# SINGAPOREAN NOTICES TO MARINERS

Edition No. 4/2023

FIX AS NEA-CHG	1°2	20'N				
	Delete		104°05'E				
CORRECTION NO.	SNM EDN NO.	LAST CORRN NO.	(	CHART NO.	Loca	ation on C	
15	04	11		GSP1/SP1			Х

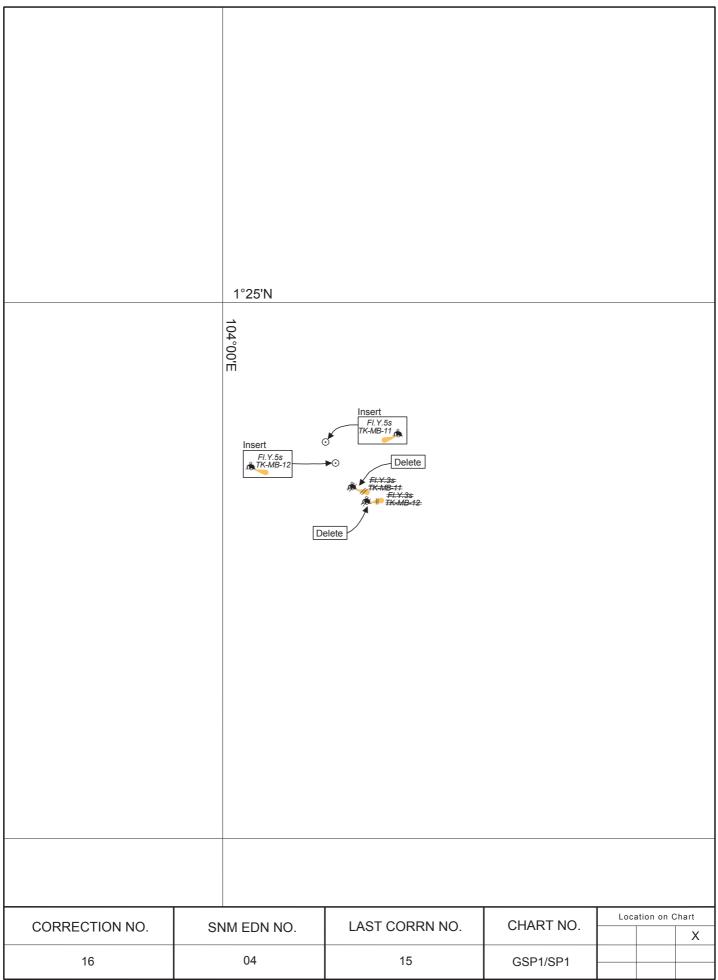
GSP1/SP1	7 Ed 01/02/23 Last NM 1	1/2023 (Maritime and Port Aut	hority of Singapore)	*NM 15/2023
Insert	FI.Y.4s, NEA-CHG		1°19·03'N	104°03·59'E
Delete	🖗 FI.Y.4s, NEA-CHG		1°20∙02'N	104°02·52'E
		(Maritime and Port Aut	hority of Singapore)	*NM 16/2023
Insert	🔶 FI.Y.5s, TK-MB-11		1°23·70'N	104°00·95'E
Insert	FI.Y.5s, TK-MB-12		1°23·50'N	104°01·05'E
Delete	🐥 Fl.Y.3s, TK-MB-11		1°23·26'N	104°01·21'E
Delete	📥 FI.Y.3s, TK-MB-12		1°23·13'N	104°01·34'E
		(Indonesia Notice No. 5	52/593/2022 & 07/82/2023)	NM 17/2023
Amend	limit of restricted area, TTT	⁺ from:	1°10·36'N	103°40·20'E
			1°10∙54'N	103°40·11'E
			1°10·77'N	103°40·11'E
			1°10·77'N	103°40·33'E
			1°10·49'N	103°40·74'E
			1°09·64'N	103°41·15'E
		to:	1°10·36'N	103°40·20'E
			1°10·49'N	103°40·15'E
			1°10·67'N	103°40·11'E
			1°10∙84'N	103°40·11'E
			1°10·32'N	103°40·84'E
			1°09·64'N	103°41·15'E
		(Maritime and Port Aut	hority of Singapore)	*NM 18/2023
Amend	light to FI(3)G.15s8m8/5M(	Dual Intensity)	1°14∙05'N	103°43·31'E

10 000
				-		_
				-		-
					_	5
					_	5000
	Amend to					-
				-	1° 10'	-
	103°40'E					0 1000
					_	1000 METRES
				-		
					_	
					-	
				-		
			<b></b>			
CORRECTION NO.	SNM EDN NO.	LAST CORRN NO.	CHART NO.	Loca	ation on (	Chart
17	04	37/2022	500			X

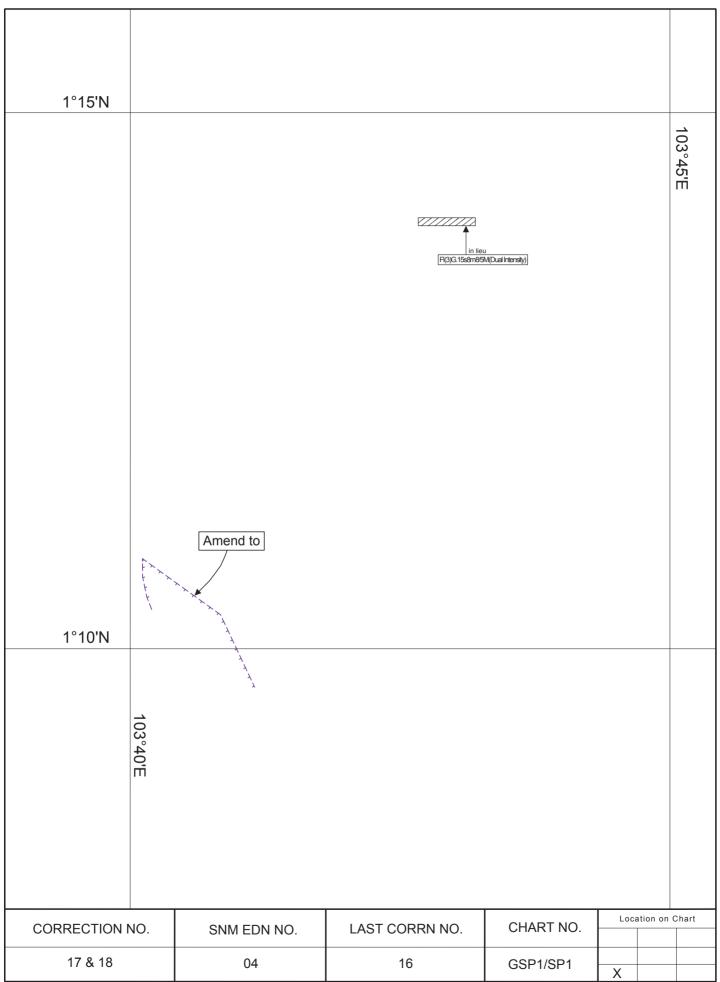
500	8 Ed 15/09/17 Last NM 37/2022	(Indonesia Notice No. 52/593/2022 & 07/82/2023)	NM 17/2023
Amend	limit of restricted area, TTTT from	: 1°10·36'N	103°40·20'E
		1°10·54'N	103°40·11'E
		1°10·77'N	103°40·11'E
		1°10·77'N	103°40·33'E
		1°10·49'N	103°40·74'E
		1°09·64'N	103°41·15'E
	to:	1º40.36/N	102°40 20'E
	to:	1°10·36'N	103°40·20'E
		1°10·49'N	103°40·15'E
		1°10·67'N 1°10·84'N	103°40·11'E
		1°10·32'N	103°40·11'E 103°40·84'E
		1°09·64'N	103°40'84 E
501	7 Ed 01/09/15 Last NM 11/2023	(Indonesia Notice No. 52/593/2022 & 07/82/2023)	NM 17/2023
Amend	limit of restricted area, TTTT from	: 1°10·36'N	103°40·20'E
		1°10·54'N	103°40·11'E
		1°10·77'N	103°40·11'E
		1°10·77'N	103°40·33'E
		1°10·49'N	103°40·74'E
		1°09·64'N	103°41·15'E
	to:	1°10·36'N	103°40·20'E
		1°10·49'N	103°40·15'E
		1°10·67'N	103°40·11'E
		1°10·84'N	103°40·11'E
		1°10·32'N	103°40·84'E
		1°09·64'N	103°41·15'E
		(Maritime and Port Authority of Singapore)	*NM 18/2023
